Addendum to Statement of Environmental Effects from Urbis

**TOWER 2, LEVEL 23
DARLING PARK, 201 SUSSEX ST
SYDNEY NSW 2000**

LDA2016/0395: 25 - 27 EPPING ROAD, MACQUARIE PARK

This Addendum Statement of Environmental Effects (SEE) is prepared by Urbis Pty Ltd on behalf of Greenland (Sydney) Lachlan's Line Macquarie Park Development Pty Ltd (Greenland) to the City of Ryde Council (Council) in support of amended drawings submitted under Section 55 of the Environmental Planning and Assessment Regulations 2000 (EP&A Regs) in relation to Development Application LDA2016/0395 (SNPP ref: 2017SNH012 DA).

Figure 16 – Amended DA West Elevation showing Buildings J and K on Lot 105 (Jervis Circuit)

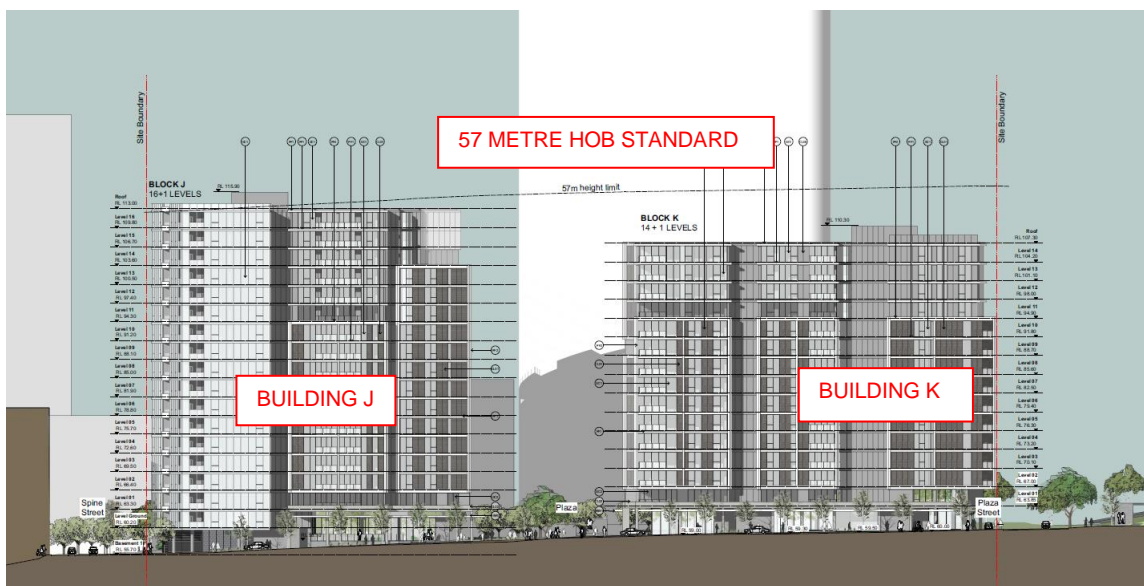
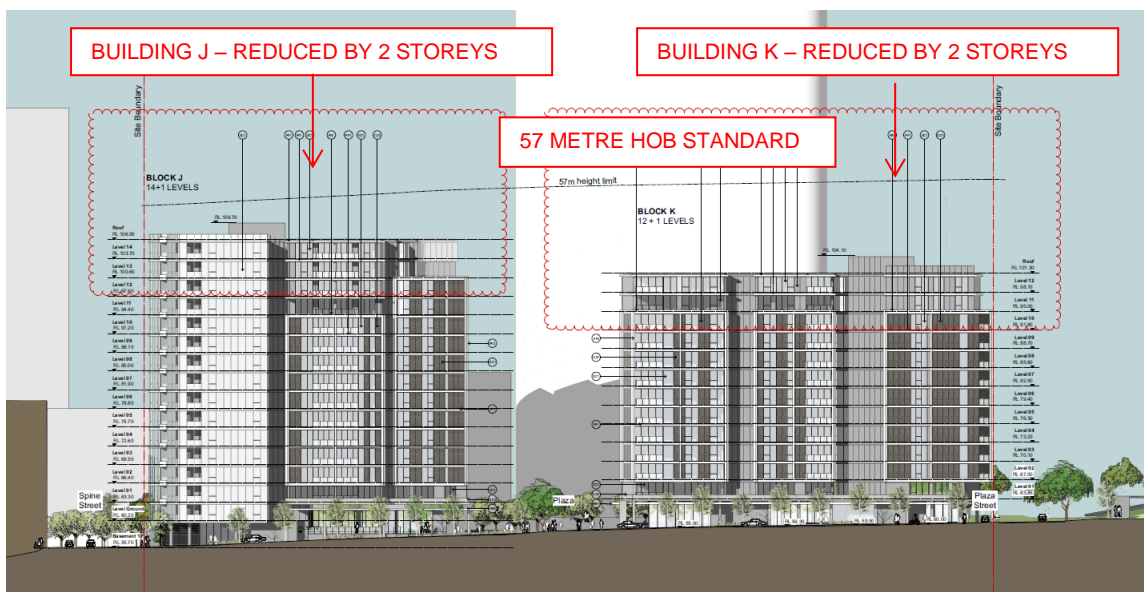
Figure 16 illustrates an elevation of Building J and K with the proposed reductions in heights.

Figure 18 – Amended DA East Elevation showing Buildings M, L1, L2, L3, L4 and L5 (Jarvis Circuit)

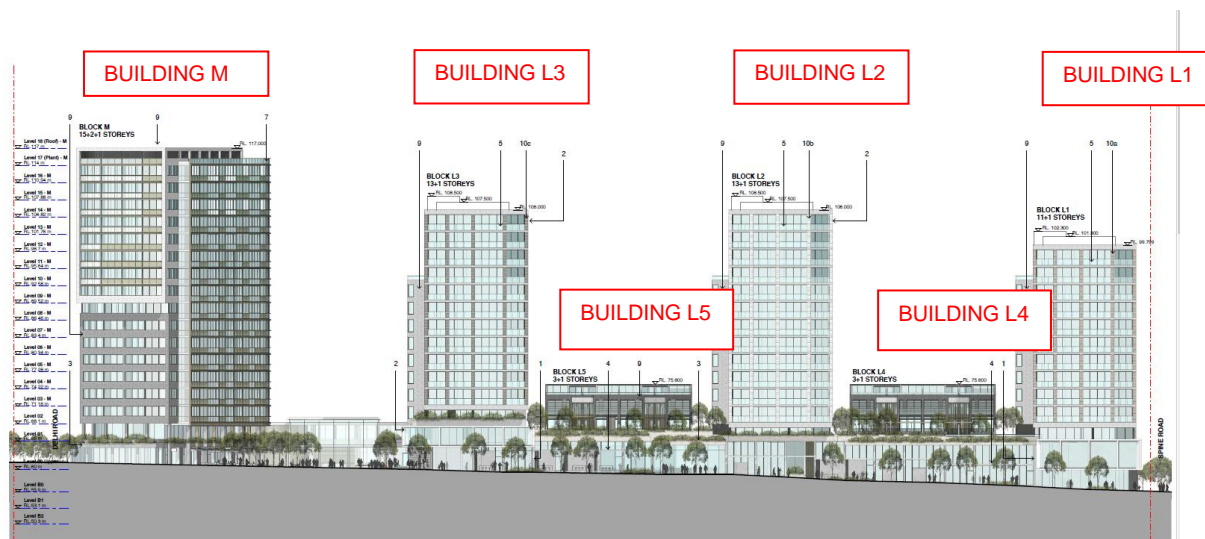
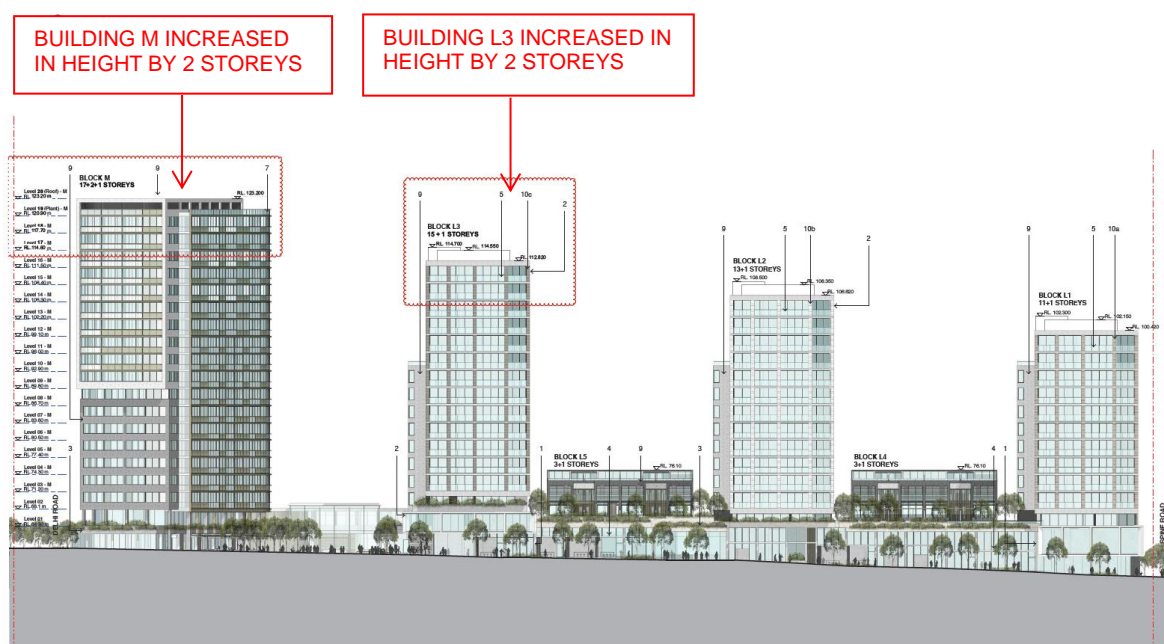
Figure 18 illustrates the proposed increase in height to Building L3 and M.
